COMMISSION MEETING

2018 Development Services Code

Item Number: 2018-2186

PUBLIC REVIEW COMMENTS RECEIVED with DSG'S RESPONSE

Figure 11.2

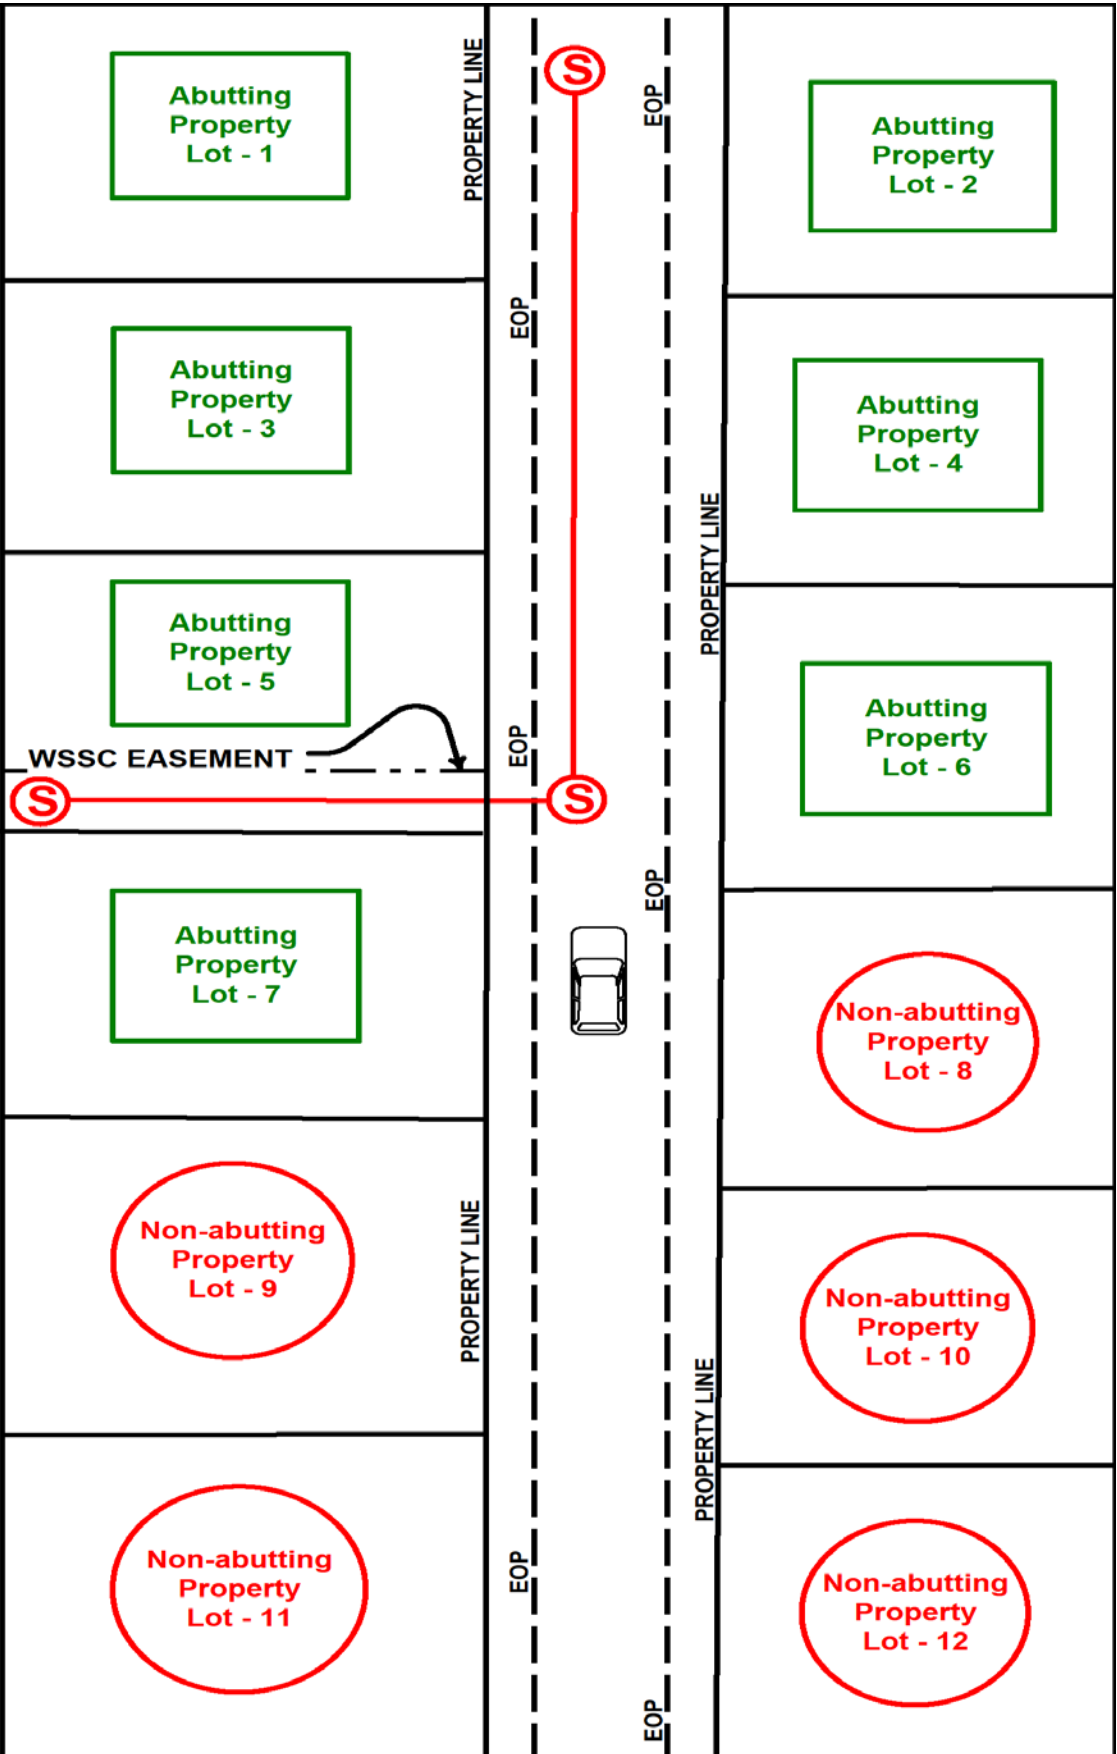
Figure 11.2

DSG Response/Reason: Look at the side property line on Lot 8 and you will see the sewer main does not abut it at any point. The fact that the main is not physically abutting the property at any point means that we will do a non-abutting connection review to determine if an angled connection will be allowed. The sketch will remain as-is.
